**STATE OF HAWAII
DEPARTMENT OF TRANSPORTATION
AIRPORTS**

**ADDENDUM NO. 1
FOR
APRON LIGHT REPLACEMENT
AT
KAHULUI AIRPORT
KAHULUI, MAUI, HAWAII
AND
LANAI AIRPORT
LANAI CITY, LANAI, HAWAII
STATE PROJECT NO. AS1037-12R
AIP PROJECT NO. 3-15-0006-064-2025**

April 2, 2026

ELECTRICAL DEMOLITION PLAN 7

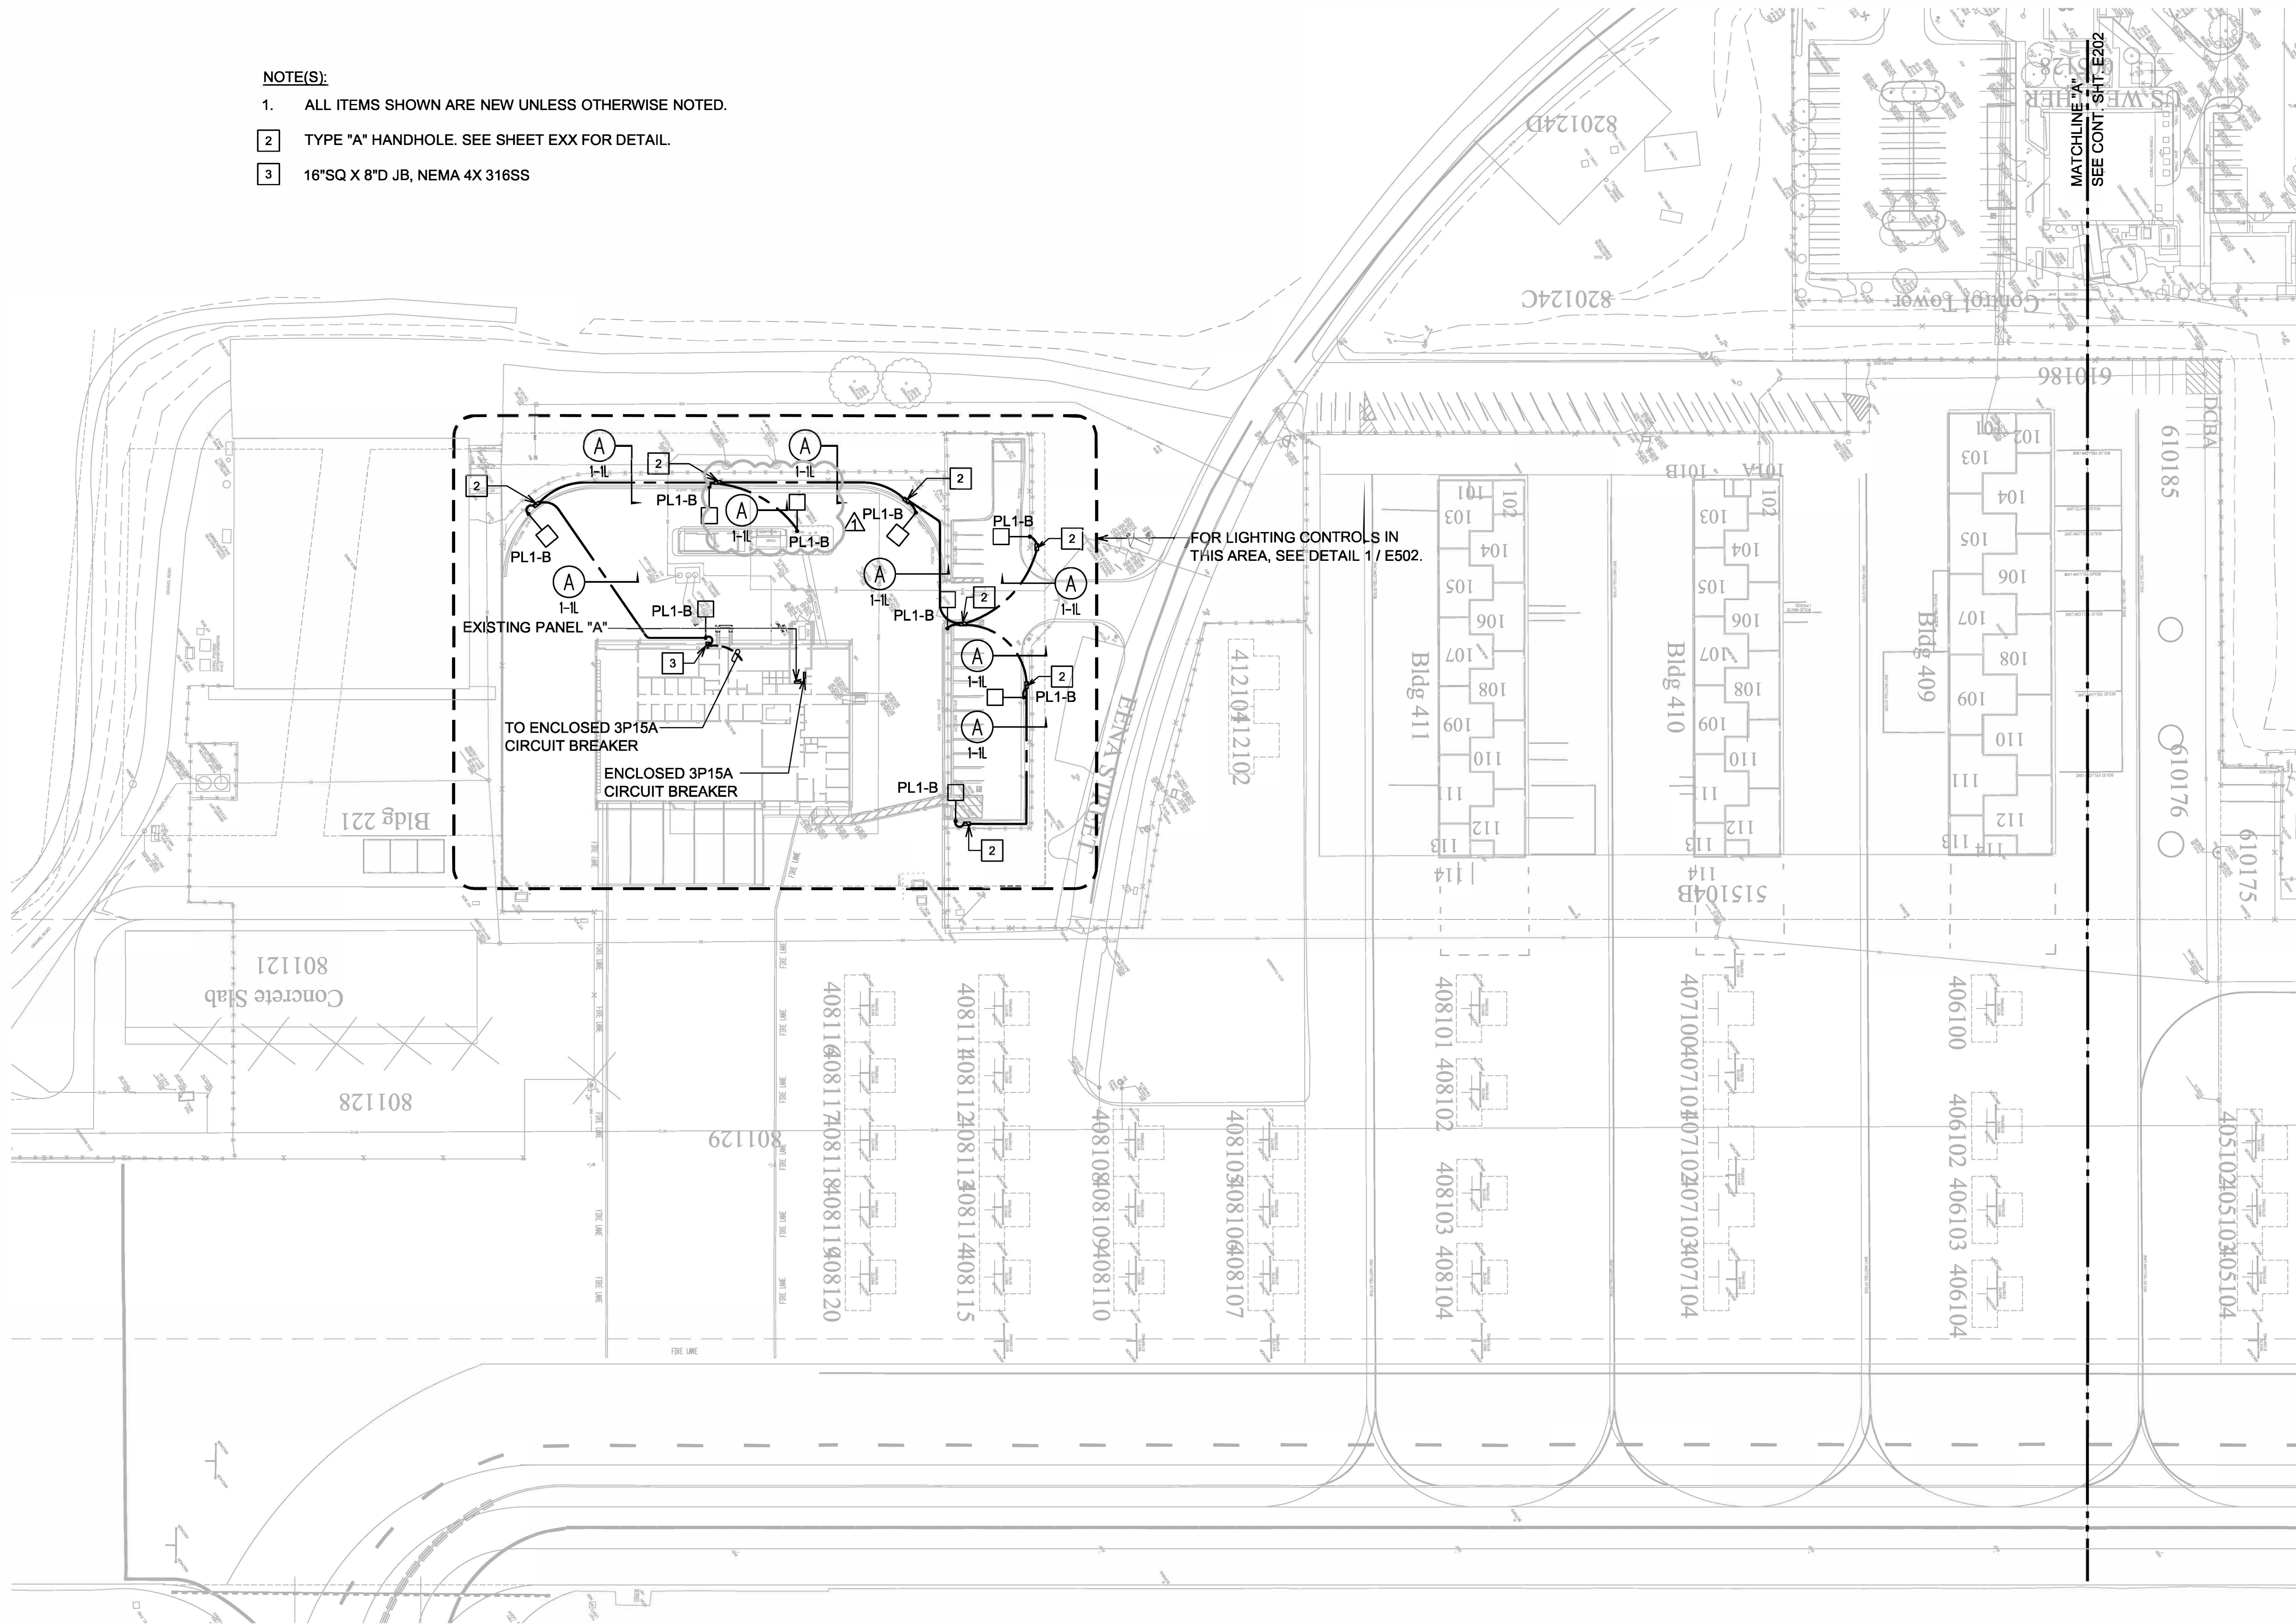
4. Delete **PLANS SHEET NO. E107, ELECTRICAL DEMOLITION PLAN 7** and replace it with attached **PLANS SHEET NO. ADD. 1 E107, ELECTRICAL DEMOLITION PLAN 7**.

ELECTRICAL PLAN 1

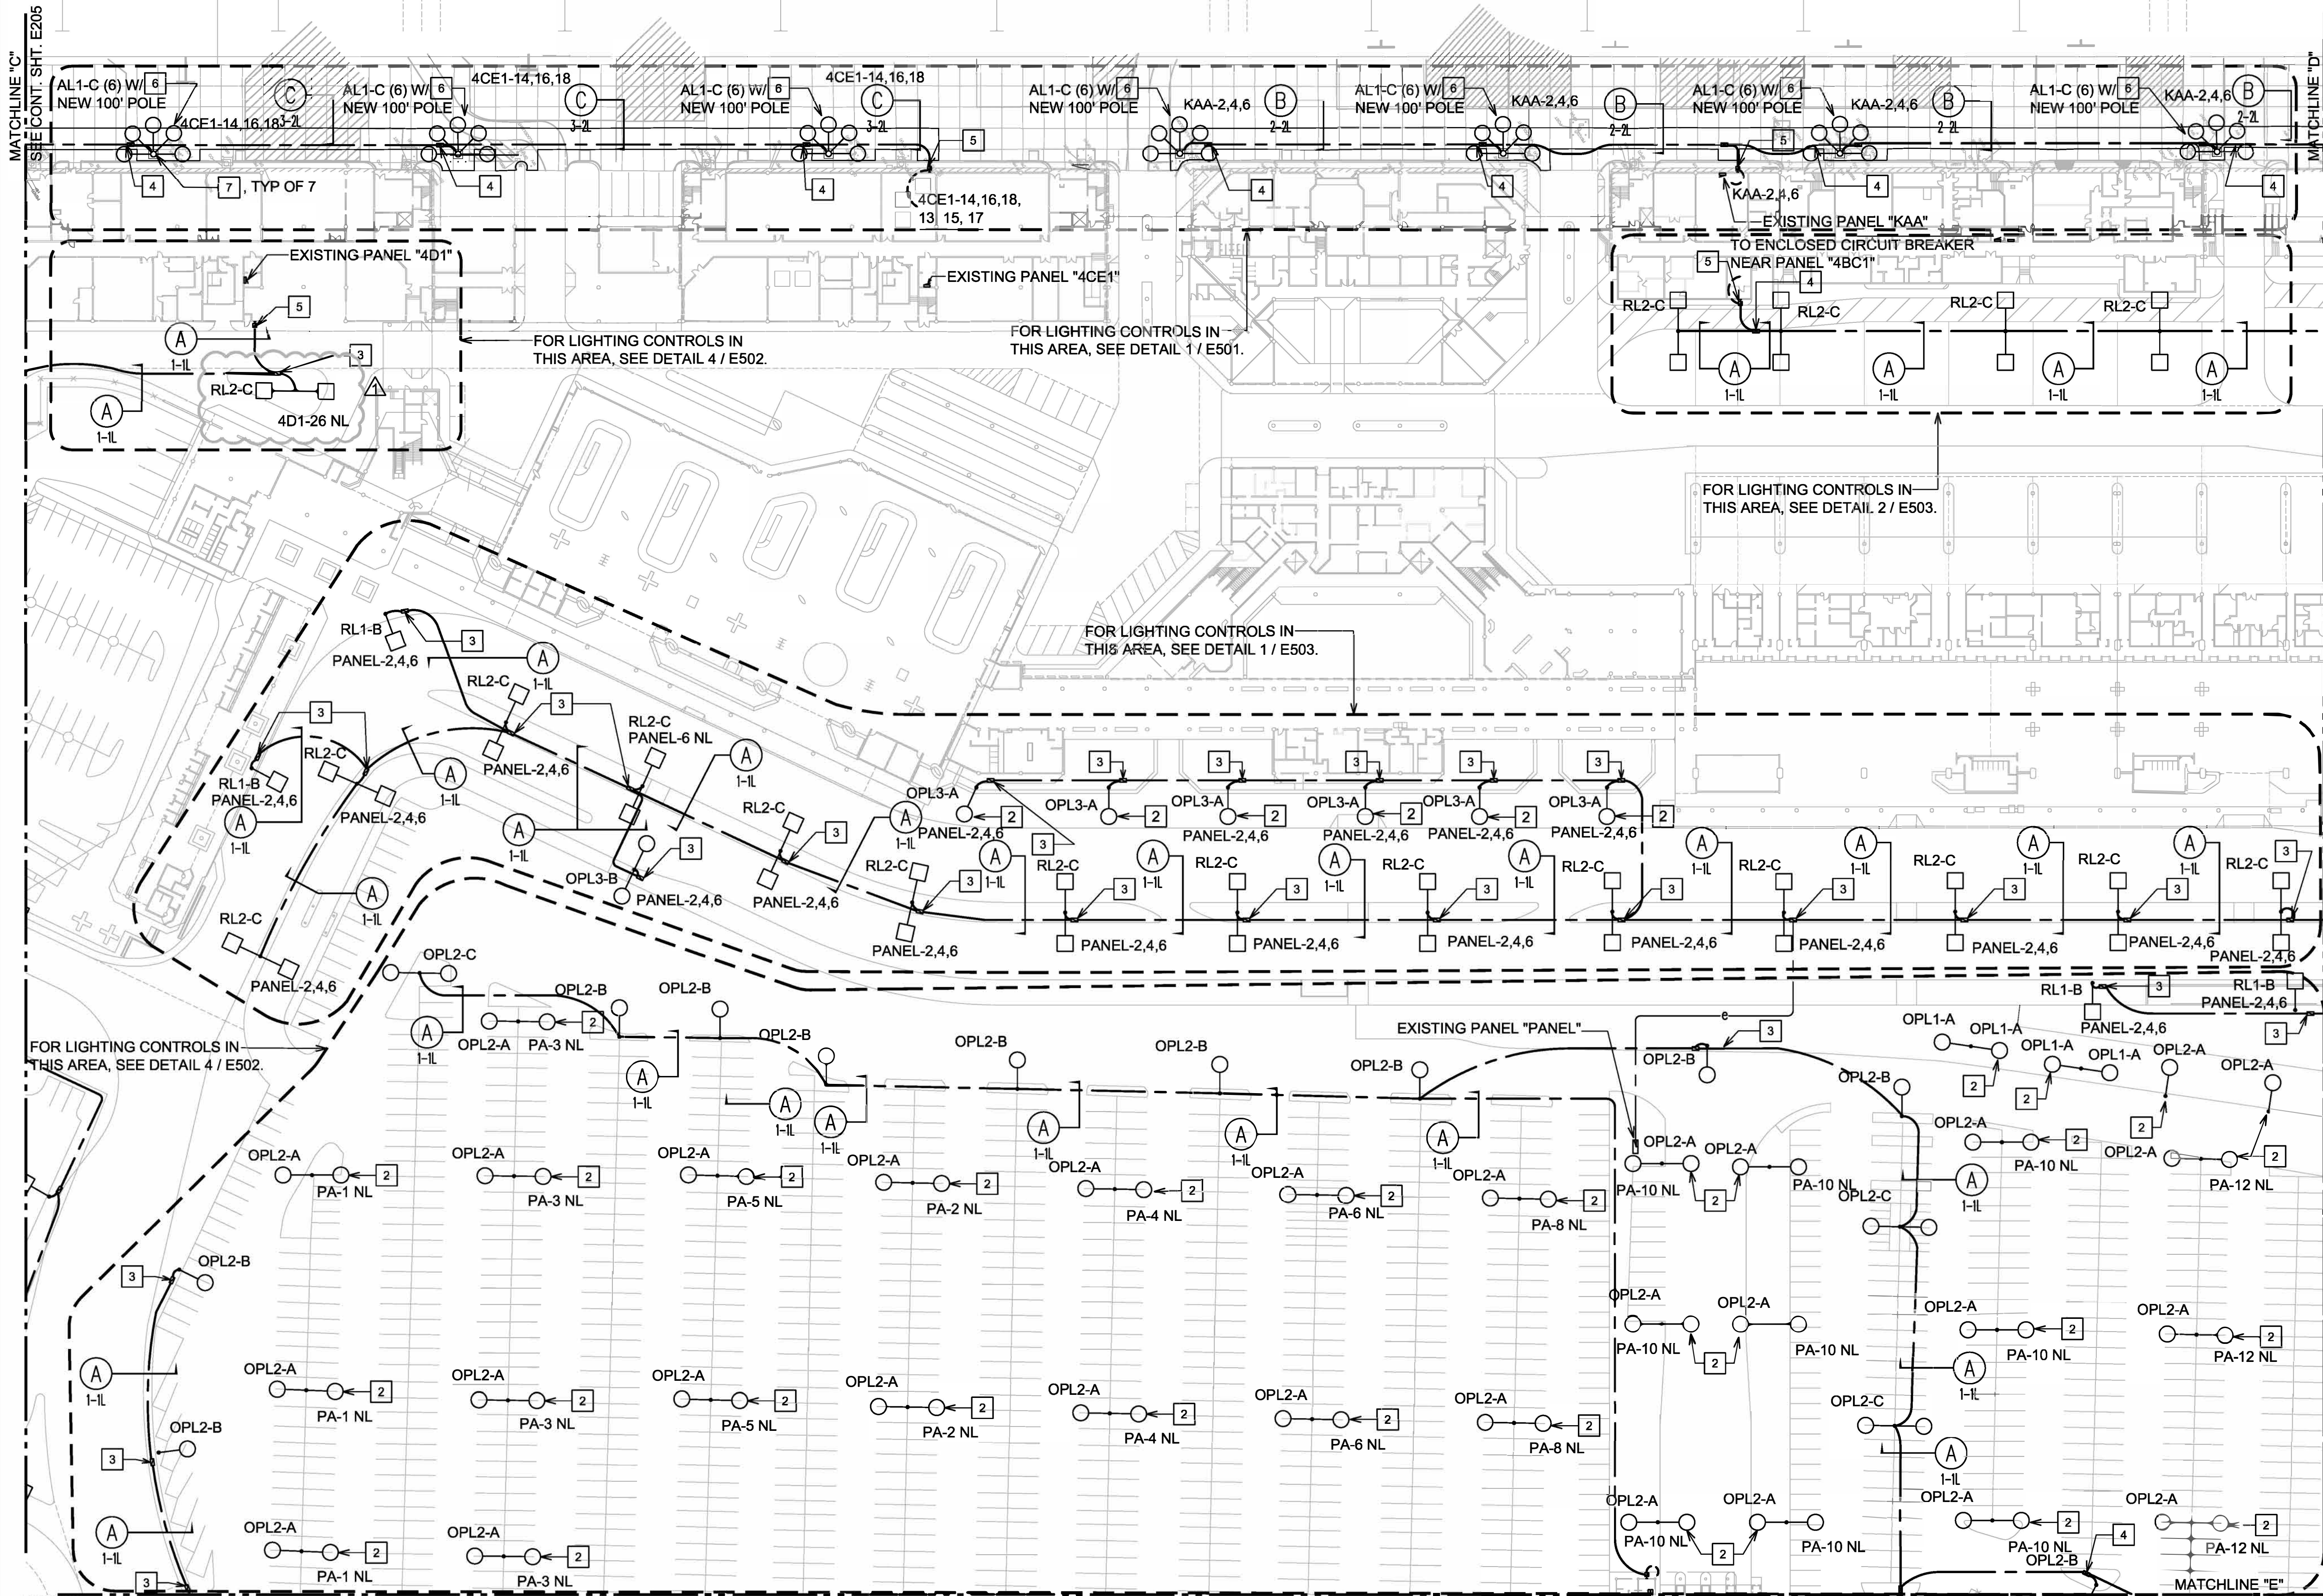
5. Delete **PLANS SHEET NO. E201, ELECTRICAL PLAN 1** and replace it with attached **PLANS SHEET NO. ADD. 1 E201, ELECTRICAL PLAN 1**.
6. Delete **PLANS SHEET NO. E206, ELECTRICAL PLAN 6** and replace it with attached **PLANS SHEET NO. ADD. 1 E206, ELECTRICAL PLAN 6**.

ELECTRICAL PLAN 6

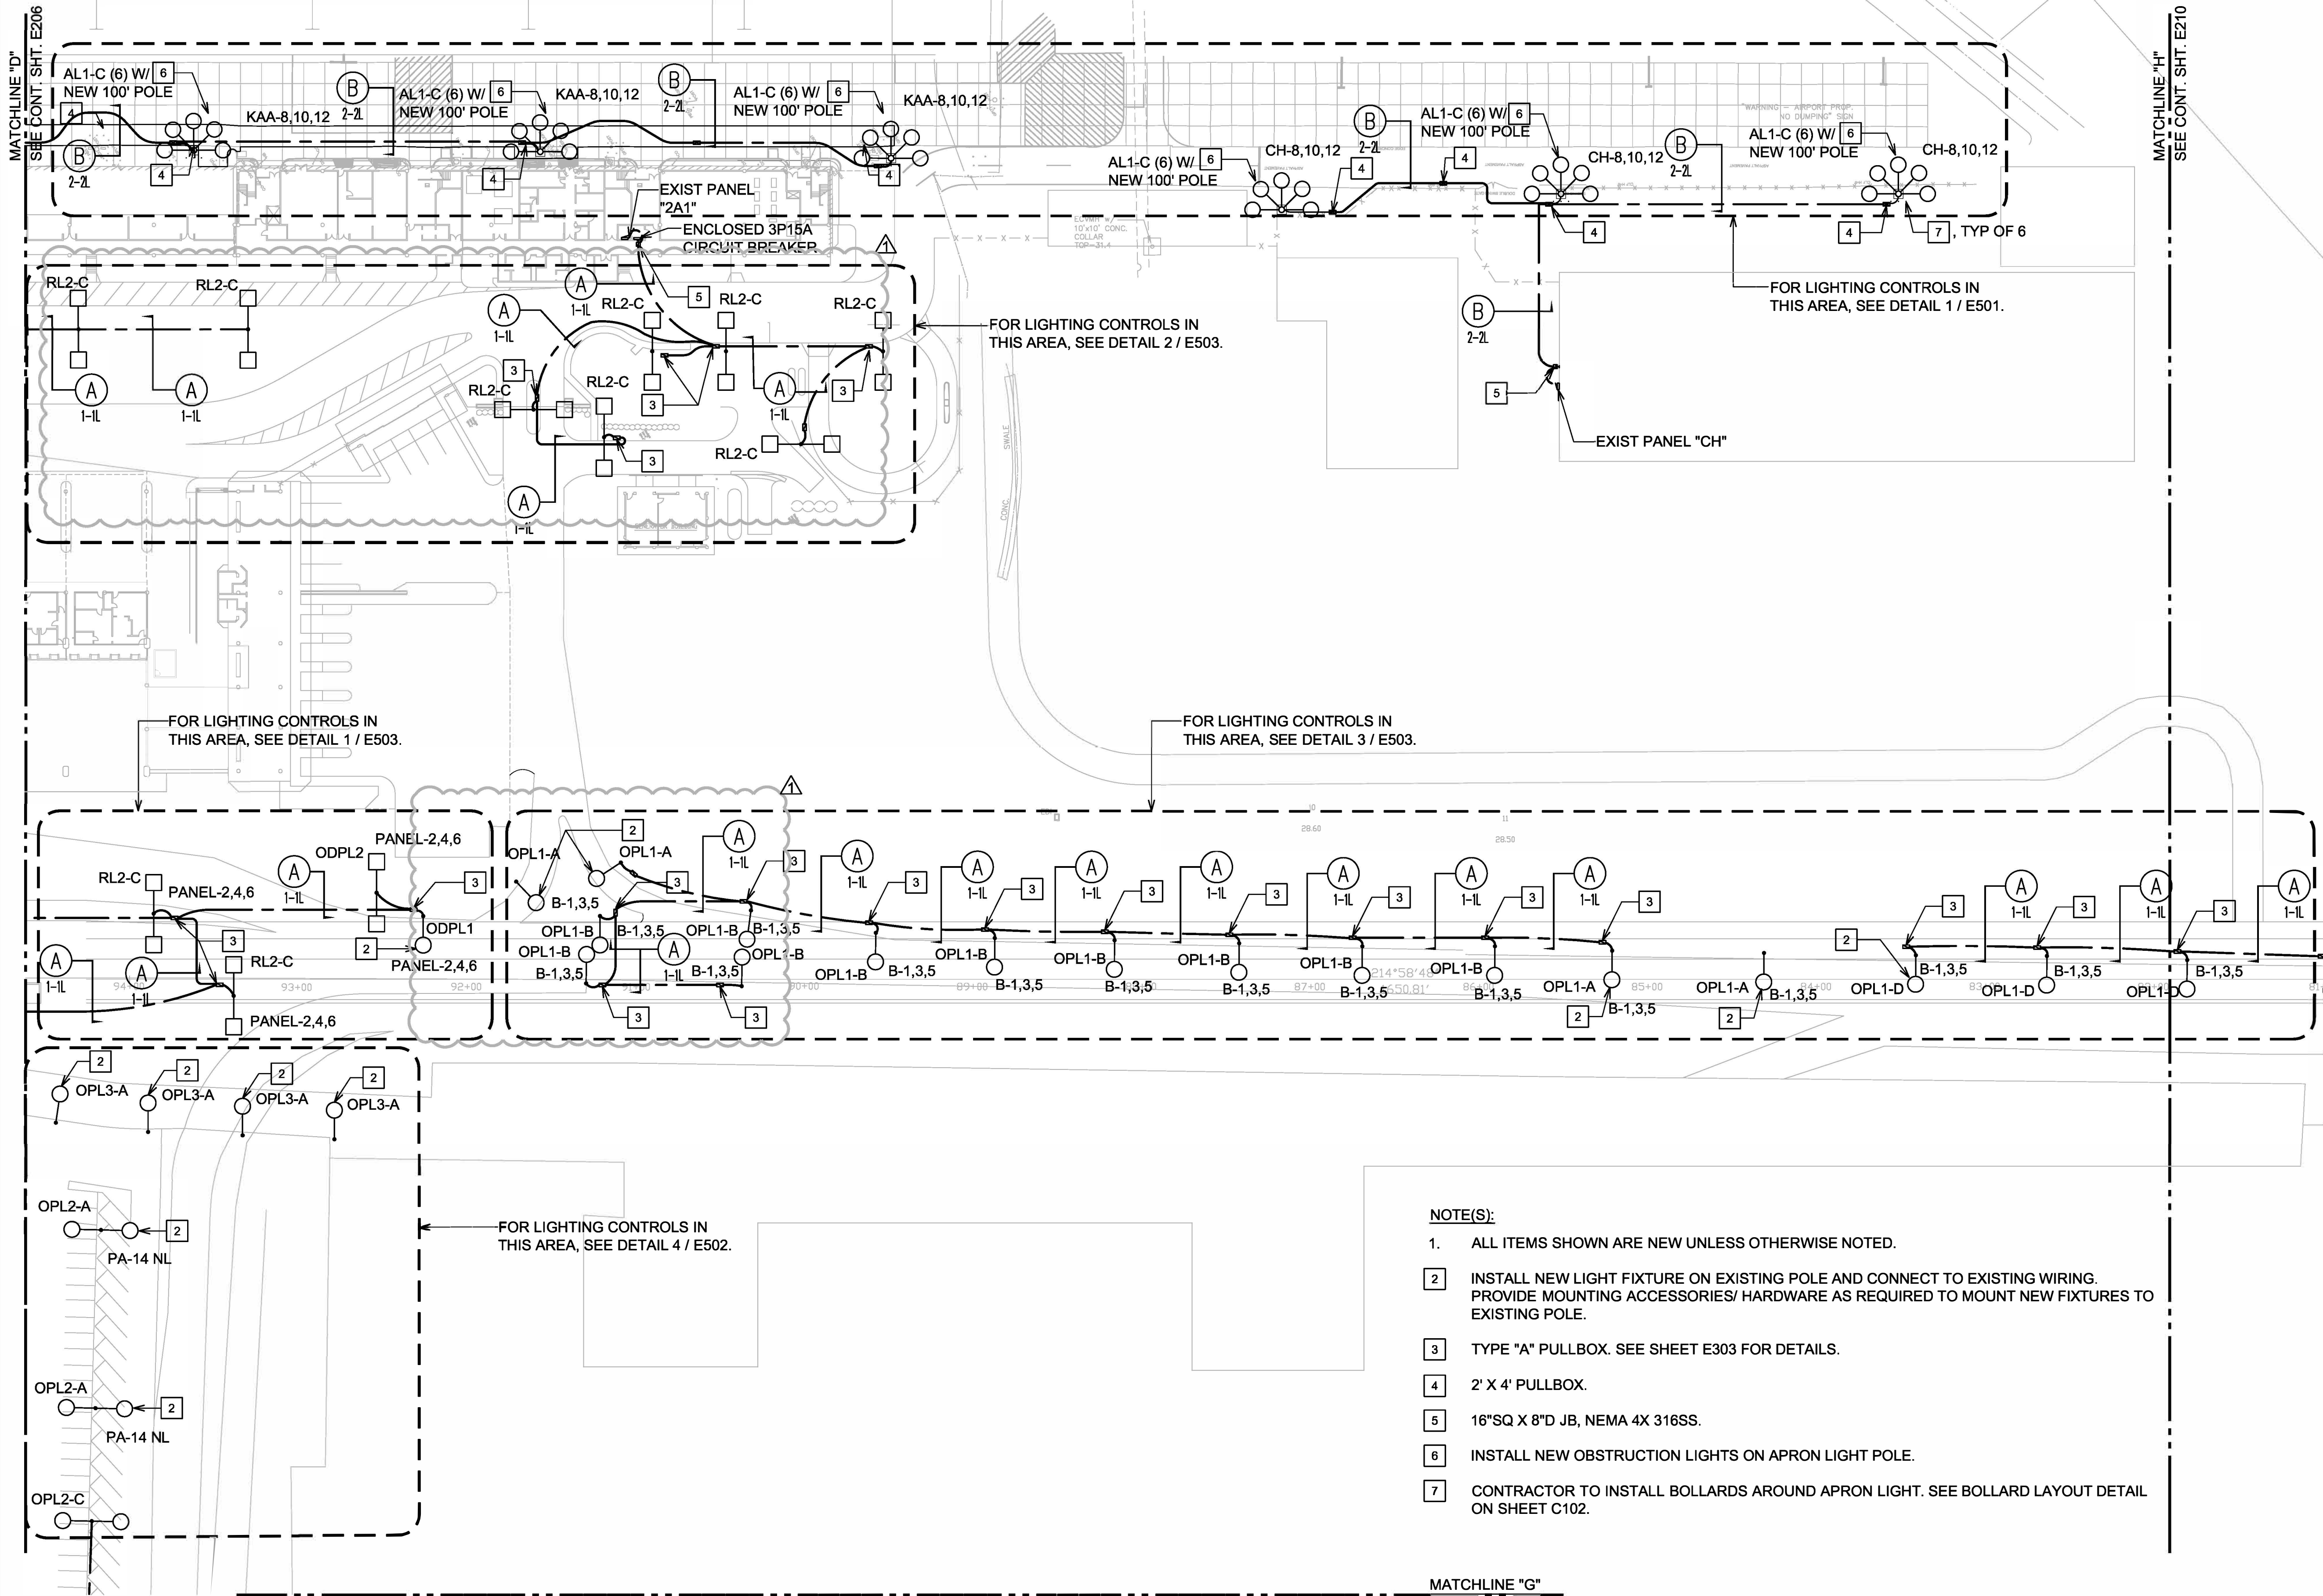
40. On the current lighting fixture schedule there are Type AL1-A fixtures listed, but we cannot find any on the plans. Type RL2-D fixtures are shown on Sheet E206 upper left side of the drawing, but not on the fixture schedule. Type PL1-A is on the fixture schedule and on sheet E211. Please confirm which bid item we use for this fixture?
